MI60 RF LCW PLC WATCHDOG TIMER MODIFICATIONS

Input Circuit as Received:

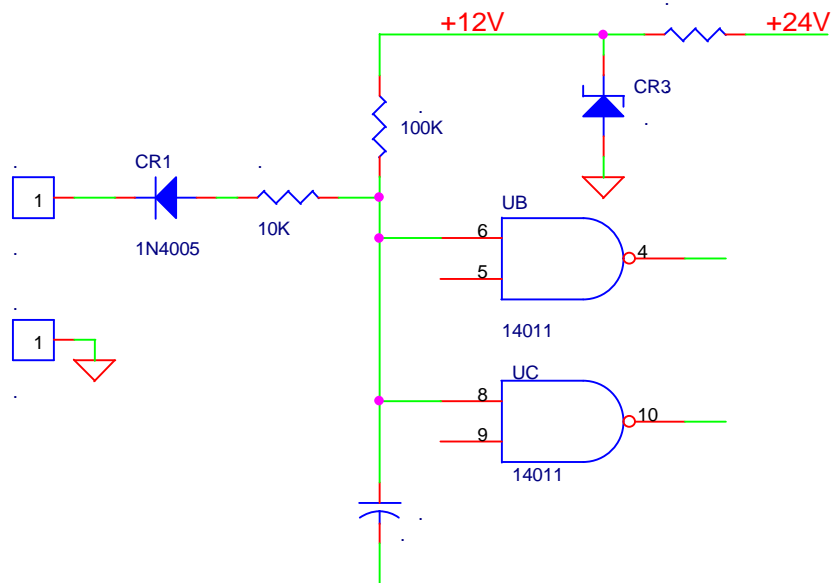
The Square-D 9050JCK22V14 timer as received is not edge triggered; the timer relay remains activated as long as the input is closed.

The following mods cause the timer to be negative-edge triggered.

As modified:
